**Soil Vapor Intrusion Mitigation Alternatives
Buildings 774, 776, 785, and 786
Former Griffiss Air Force Base
Rome, New York**

**FINAL
FEASIBILITY STUDY**

SUBJECT: FINAL FEASIBILITY STUDY
Evaluation of Alternatives and Conceptual Design
Soil Vapor Intrusion Mitigation Alternatives
Buildings 774, 776, 785, and 786
Former Griffiss Air Force Base, Rome, New York
Contract No. F41624-03-D-8601-0045
Revision 0.0
February 2010

**RESPONSE TO
U.S.EPA COMMENTS ON
DRAFT FEASIBILITY STUDY,
SOIL VAPOR INTRUSION MITIGATION ALTERNATIVES,
BUILDINGS 774, 776, 785 and 786,
Former Griffiss Air Force Base, Rome, NY.
Revision 0.0, February 2009.**

FIGURE 2-3
Building 774 and 776
2008 Sample Locations

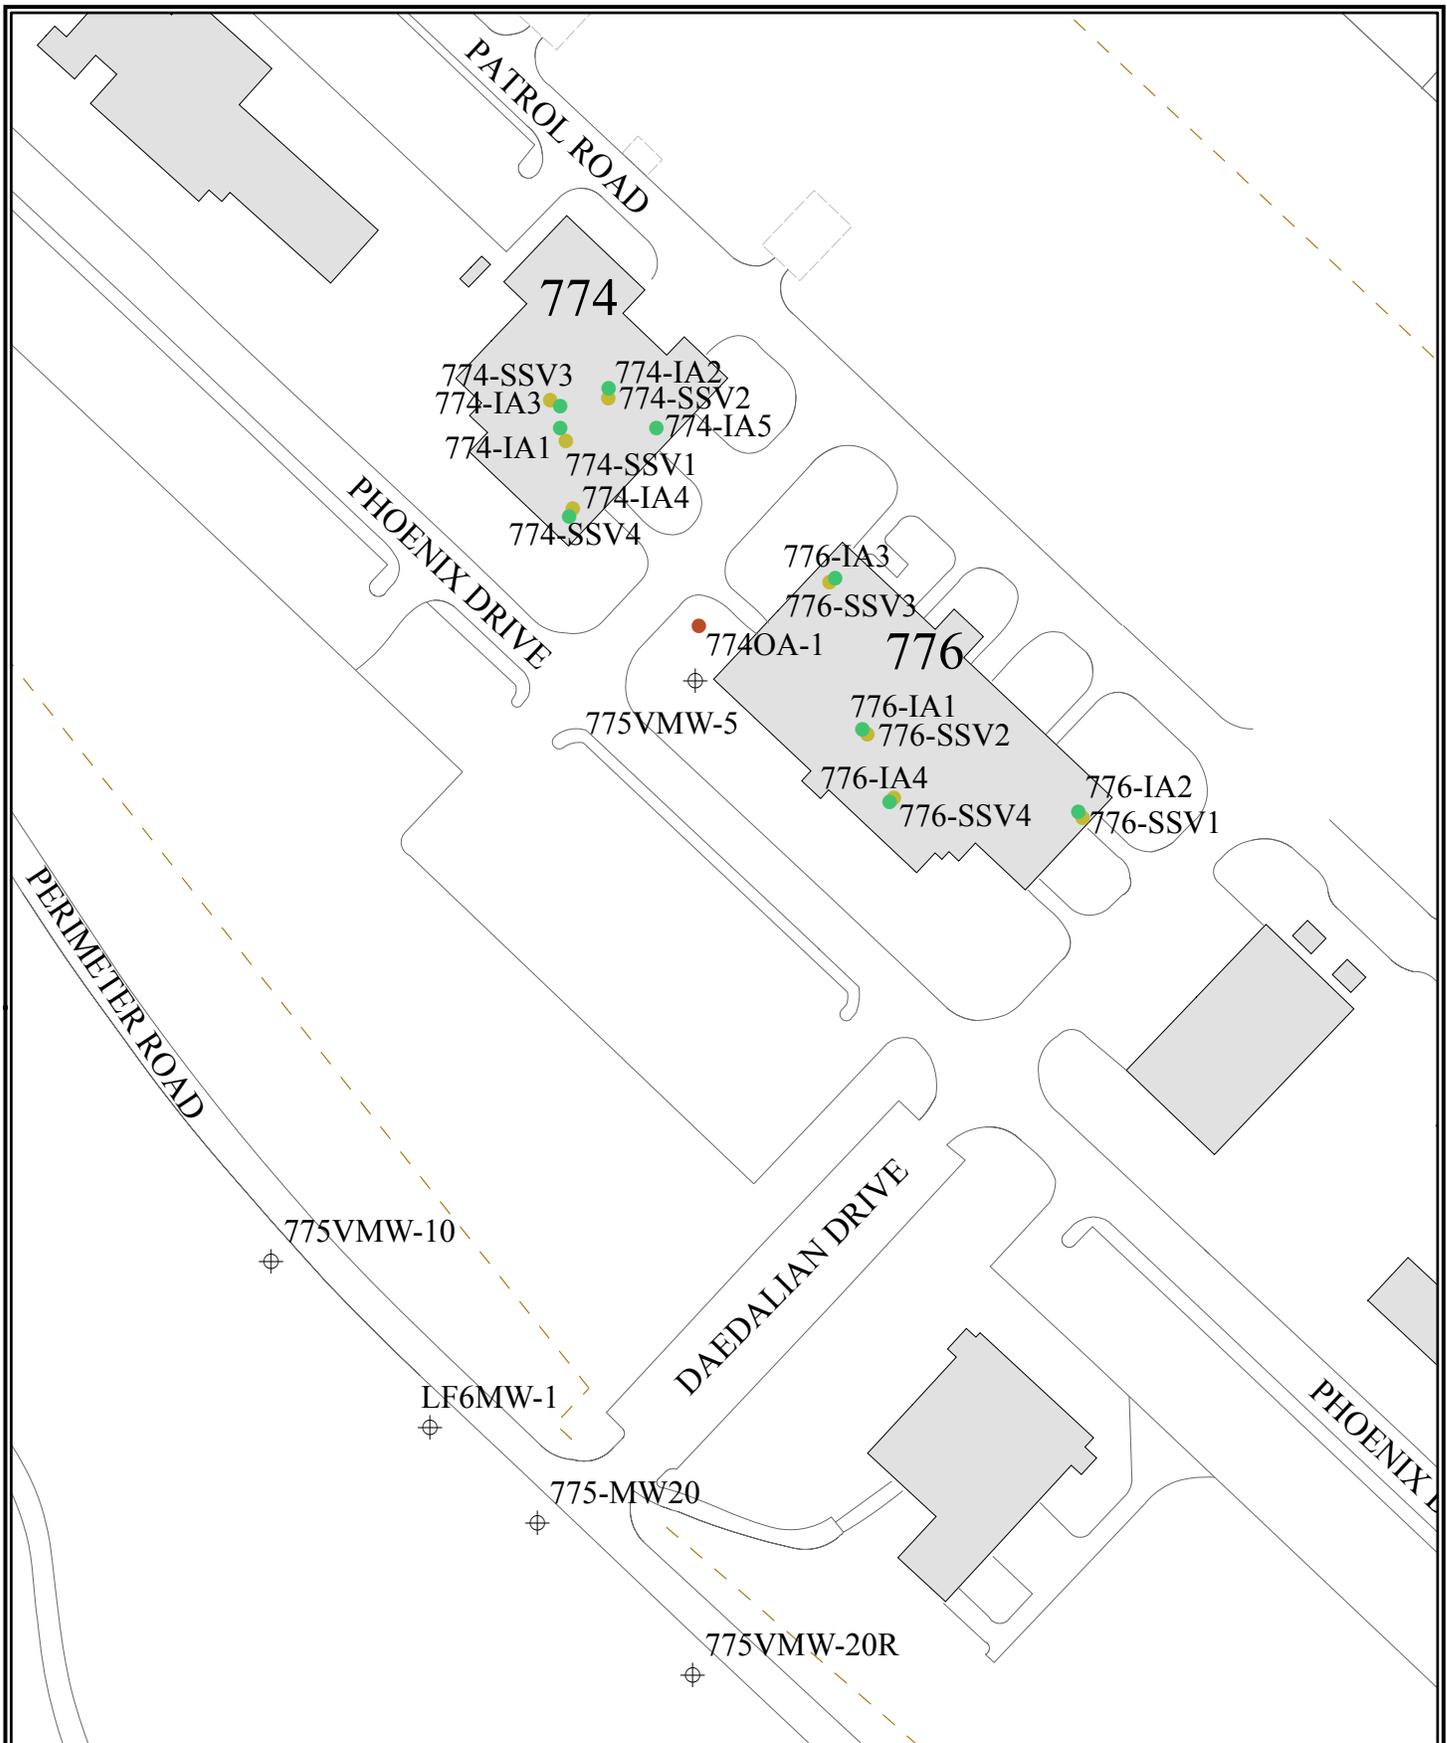
2	<p>Section 2.1.4.1.2, 2008 SVI Evaluation, Page 2-8: The location of the additional indoor air sample, collected in Building 774 in the May 2008 sampling event (due to renovation activity), has not been identified or provided on Figure 2-3 (Building 774 and 776 – 2008 Sample Locations). As such, it is unclear if the sample is representative of the area where renovation activities took place. Identify the location of the additional air sample and the location of the renovation activity within Building 774 on Figure 2-3.</p>	<p>The additional sample was accidentally omitted from the figure. It will be added in the revised version of the FS.</p>
3	<p>Table 2-12, Building 786 Short List Sub-slab Vapor Analytical Results – October 2006/April 2008, Page 2-26: It is unclear why the sub-slab vapor concentrations at 786SSV-1 differed so significantly from 81,000 ug/m³ to 19,000 ug/m³ between October 2006 and April 2008. As such, it is unclear what mechanisms within the sub-slab vapor and/or indoor air pathways exist to cause this deviation. Revise the FS to clarify and discuss possible reasons as to why the sub-slab vapor concentrations at 786SSV-1 differed from 81,000 ug/m³ to 19,000 ug/m³ between October 2006 and April 2008.</p>	<p>Fluctuations in sampling results are not uncommon. Differences between duplicates and normal samples collected at one sampling time and data are reasonably expected up to 30 percent. Fluctuations will generally be higher once the time between sampling events increases, especially in highly volatile media such as soil gas. The difference in concentrations is within one order of magnitude and therefore is not considered uncommon, especially with an 18-month interval between samples.</p> <p>Factors that contribute to that difference are the seasons, sample collection, and also analytical, as two different air analytical labs</p>

Figure 5-4
 SVI Mitigation System Operation Decision Tree

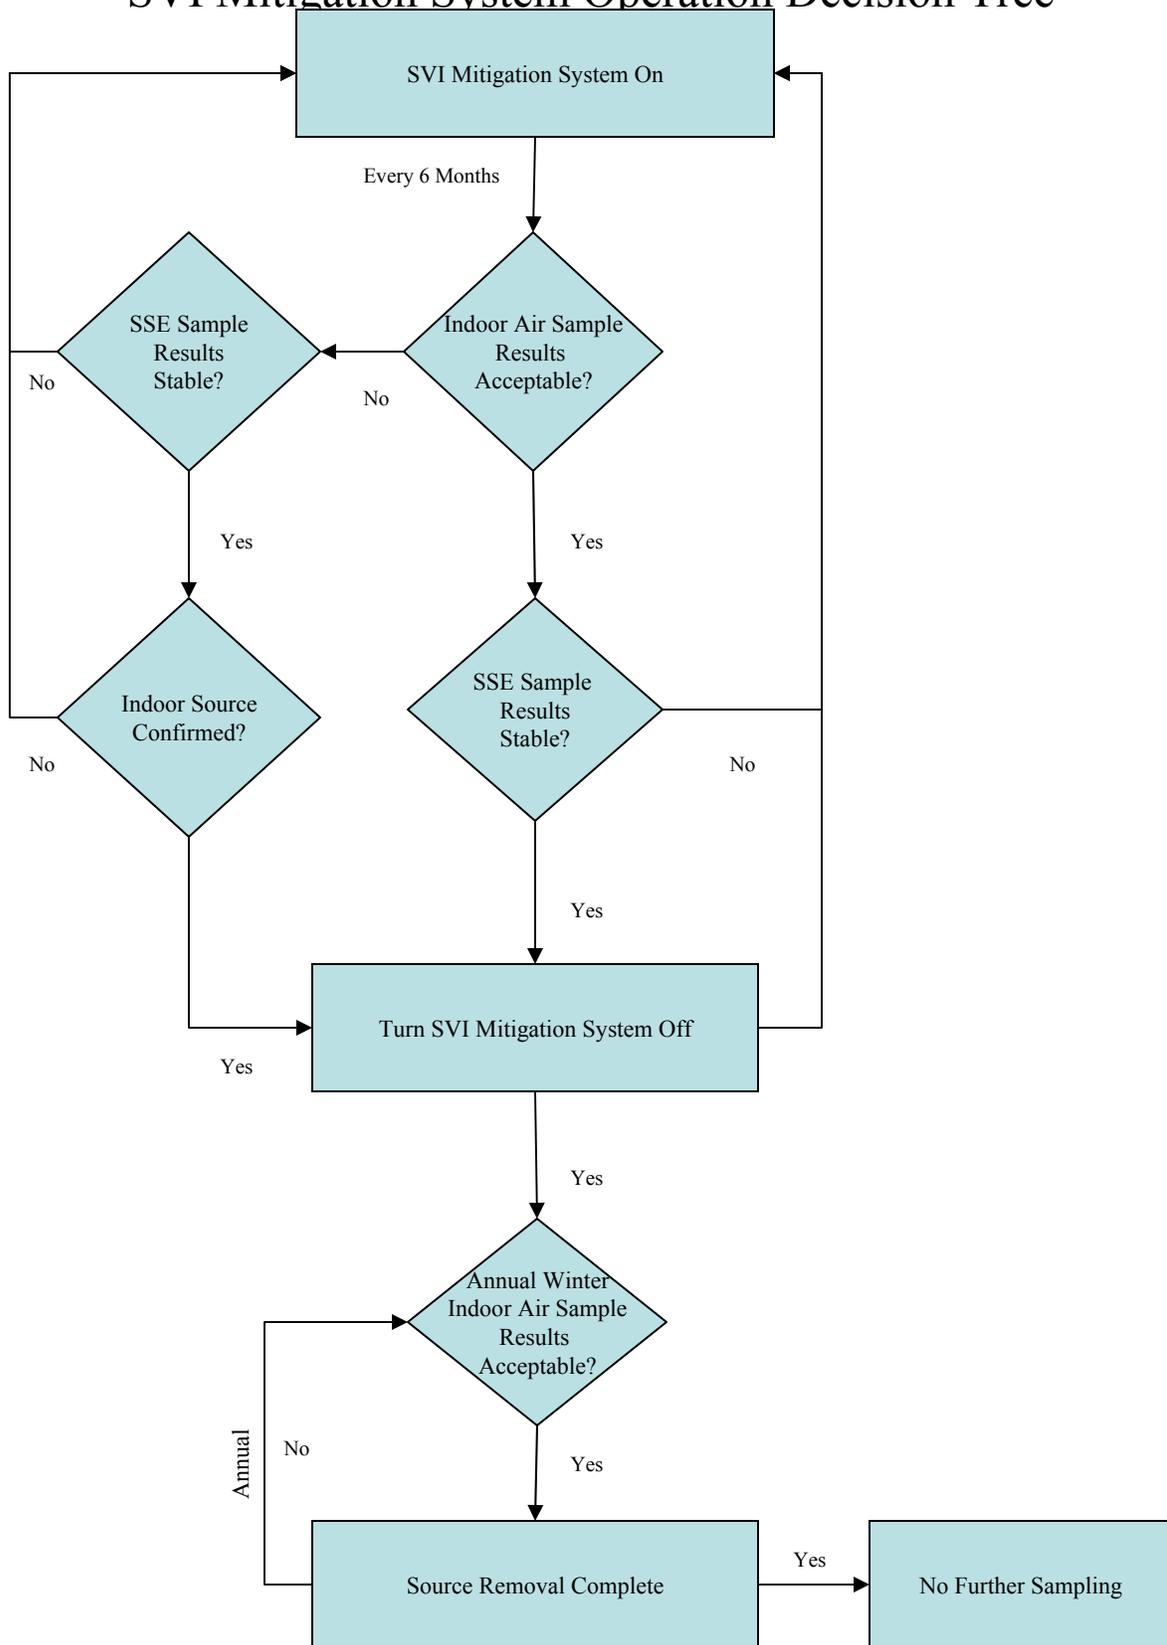
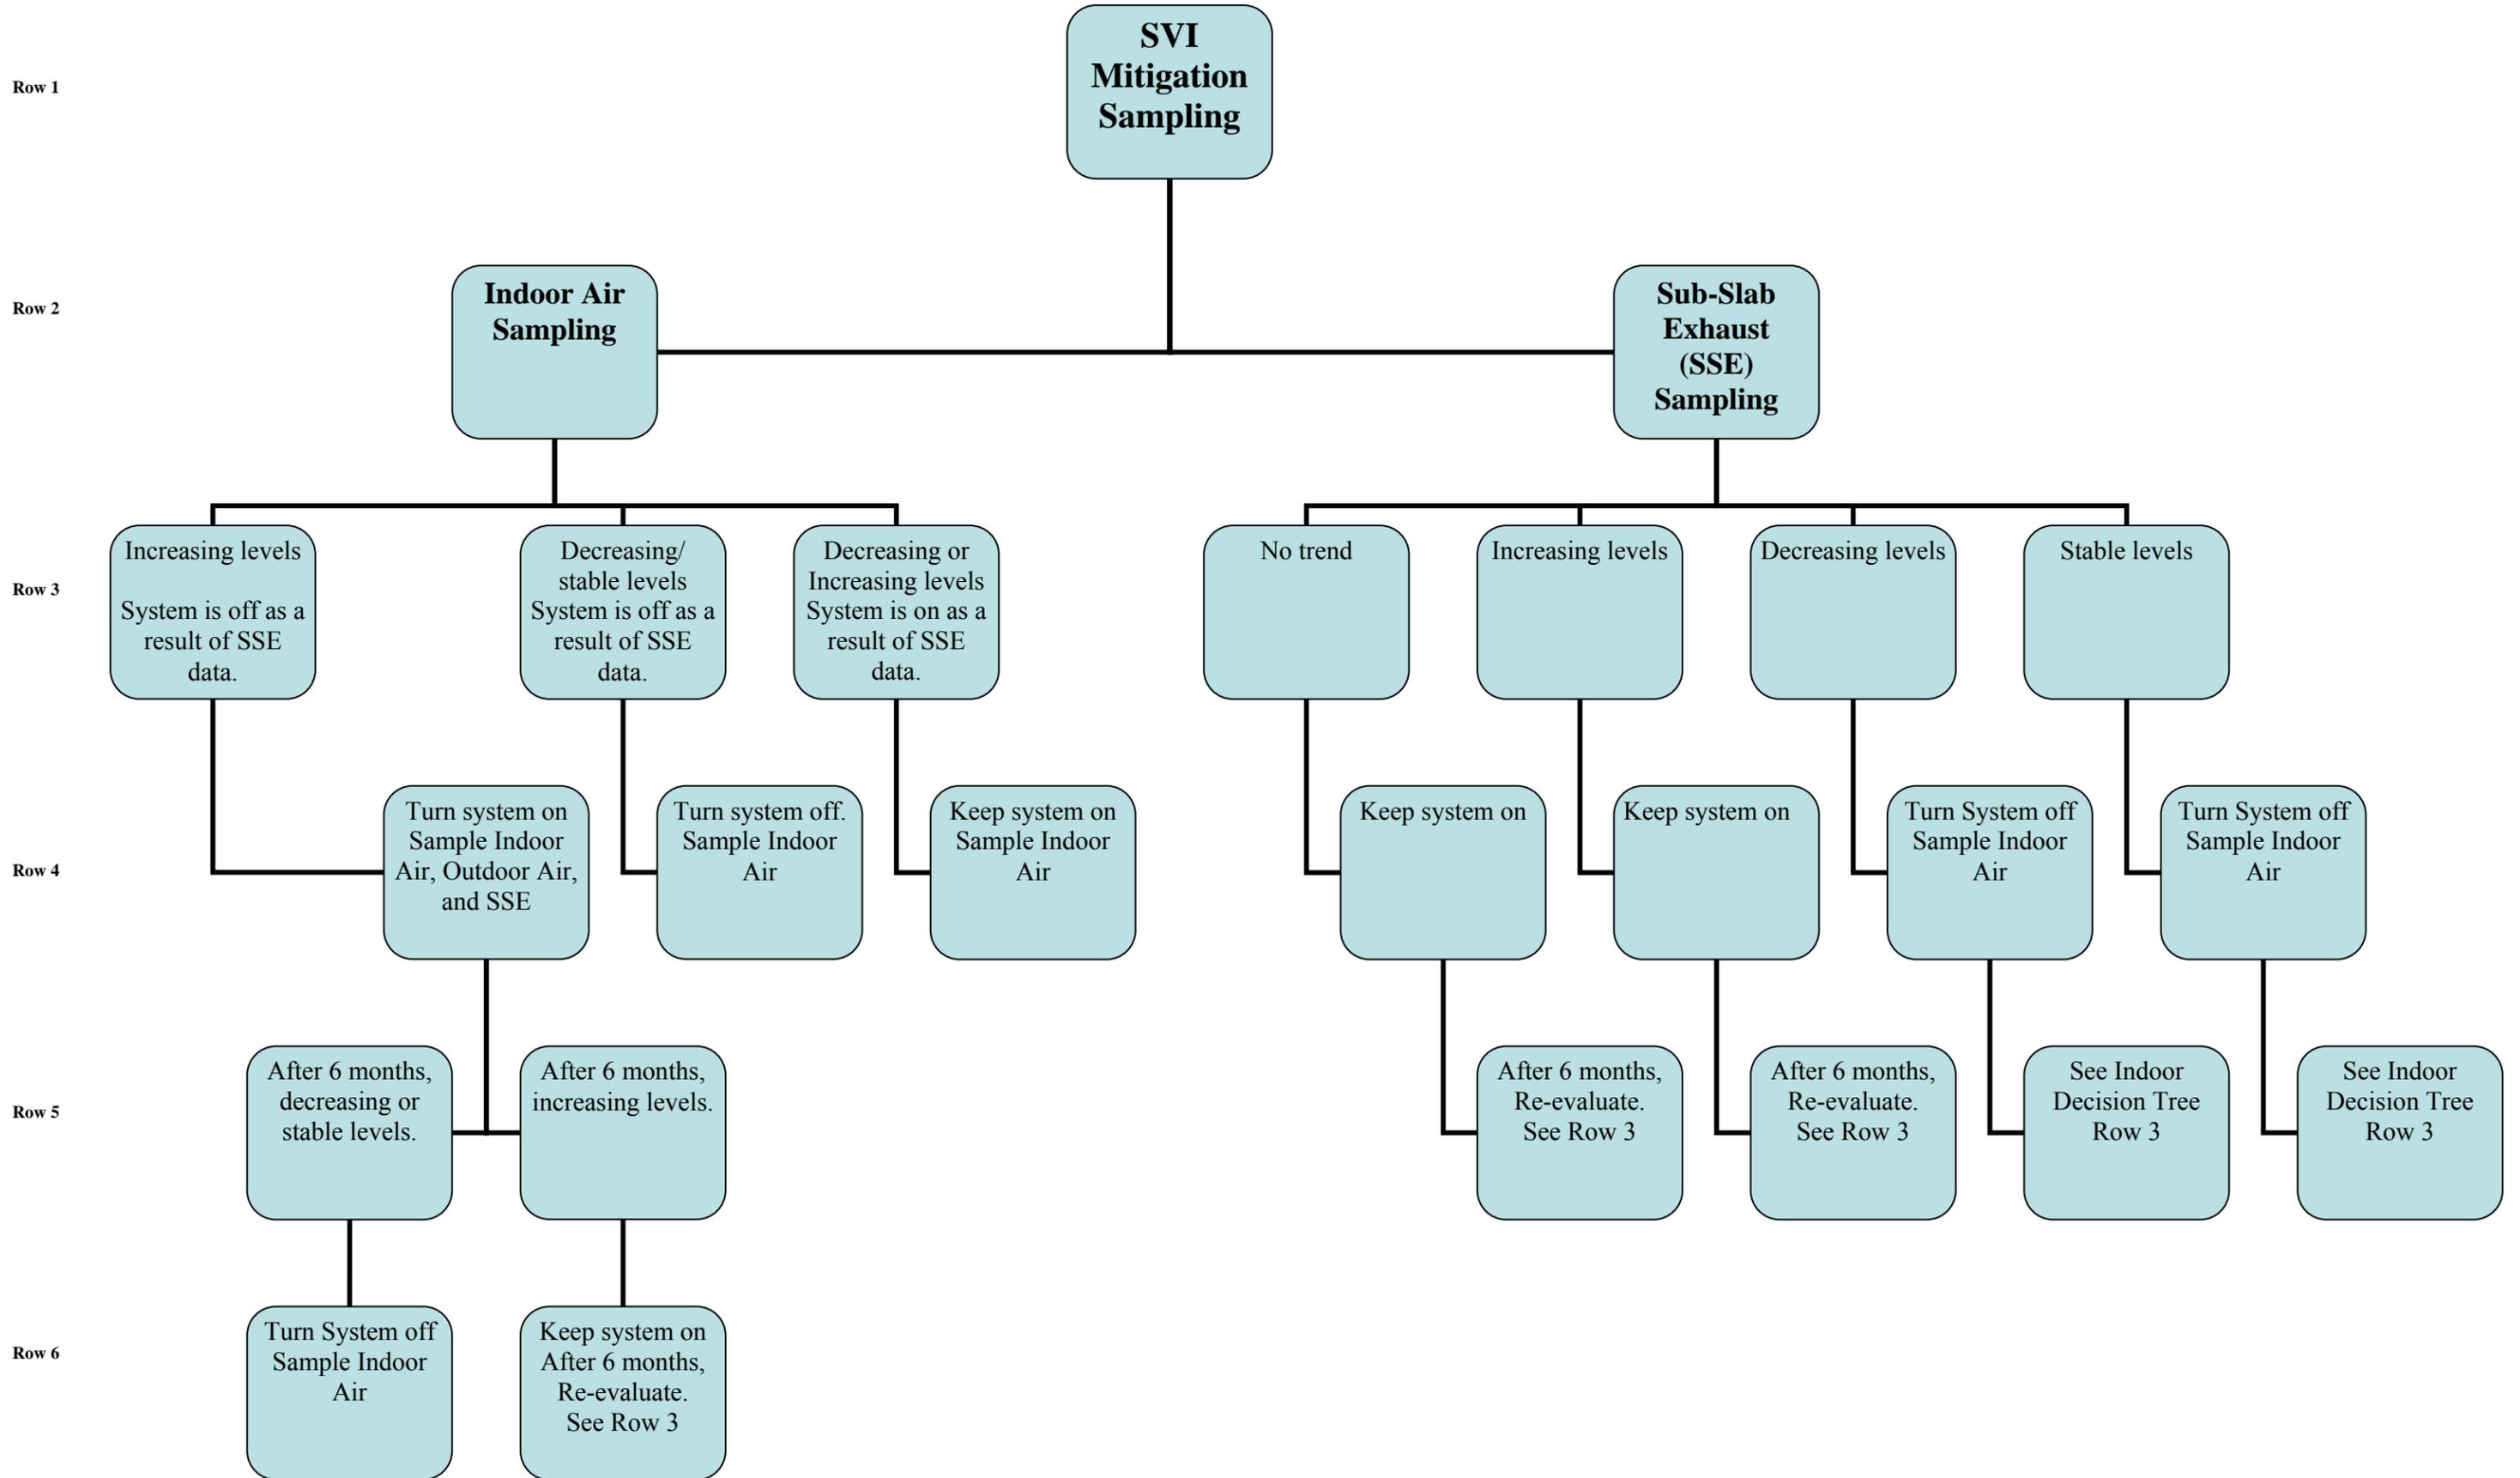
GENERAL NOTES		
#	USEPA COMMENT	RESPONSE
1	Points of compliance or preliminary remediation goals (PRGs) have not been established for Buildings 774, 776, 785, and 786 or clarified in detailed as to the remedial action objectives. As such, it is unclear how the performance of the to-be-selected remedies will be assessed, or how it will be determined if they are operating as designed. Further, without performance criteria, EPA will be unable to determine if the proposed remedy was successful or when the remedial objectives have been achieved allowing any active remedy to be shutdown. It is suggested that a detailed decision tree or flow diagram be developed for each building. Each decision tree/flow diagram should establish compliance points or PRGs to determine whether the selected remedies are operating as designed or if alternative remedies need to be evaluated. In addition, the decision trees/flow diagrams should establish these compliance points or PRGs to determine when implemented remedies have successfully addressed human health and environmental concerns and attained the intended objective, so they can be removed from operation. It should be noted that if points of compliance or PRGs and decision trees/flow diagrams are appropriately established and	As stated in the last paragraph of Section 1, Introduction, the objectives of this FS are to screen and evaluate all available alternatives and perform conceptual design for mitigation of soil vapor intrusion (SVI) into Buildings 774, 776, 785, and 786, and to recommend a preferred alternative for same. Thus, the goal of this FS and proposed work is SVI mitigation for the benefit of the occupants of these buildings (who are all workers), and any potential reduction in contaminant levels in the subsurface is incidental to the goal of this project. The project is not designed to withdraw vapors from the subsurface for the purpose of remediation, but, rather, to prevent any vapors present in the subsurface from entering the buildings. The last paragraph of Section 1, Introduction, of the FS has been revised to further emphasize this distinction. Also, a flow chart/decision tree illustrating the

achieved, the duration of any selected remedy's operation may be reduced. Points of compliance or PRGs should be based on a quantitative reduction of sub-slab vapors.	performance/evaluation criteria for the selected alternative will be added to the FS and is provided with the response to comments.
2	Also, several technology options (e.g., directional drilling, vertical drilling) for Buildings 774, 776, 785, and 786 include the discharge of extracted vapors to the atmosphere through a stack that is at least three feet taller than the highest point of the building. Based on Tables 2-5 (Building 774 Short List Sub-slab Vapor Analytical Results), 2-6 (Building 775 Short List Sub-slab Vapor Analytical Results), 2-11 (Building 785 Short List Sub-slab Vapor Analytical Results), and 2-12 (Building 786 Short List Sub-slab Vapor Analytical Results), several sub-slab vapor concentrations exceed screening levels [e.g., 19,000 micrograms per cubic meter (ug/m ³) of trichloroethylene (TCE) at 786SSV1BB]. These concentrations could warrant air emission control devices to meet current RCRA standards and should be addressed in the document for our review.	<p>Similar to the PRGs, air emissions and air emissions monitoring are generally considered part of the RA WP and therefore will be discussed in that future document.</p> <p>Several sub-slab vapor concentrations were high, however, these are most likely due to accumulated vapors and, as the conceptual design shows, the horizontal wells will remove air from under the entire slab and therefore average discharge vapor concentrations are expected to be significantly lower than the high maximum sub-slab vapor concentrations reported. Therefore, it is not believed that air emission control would be warranted; however, review of the need for air emission control will be performed as needed during the detailed design stage. Notes to this effect are included in Sections 5.2.2, 5.3.2, 5.3.3, and 5.6 of the revised FS.</p>
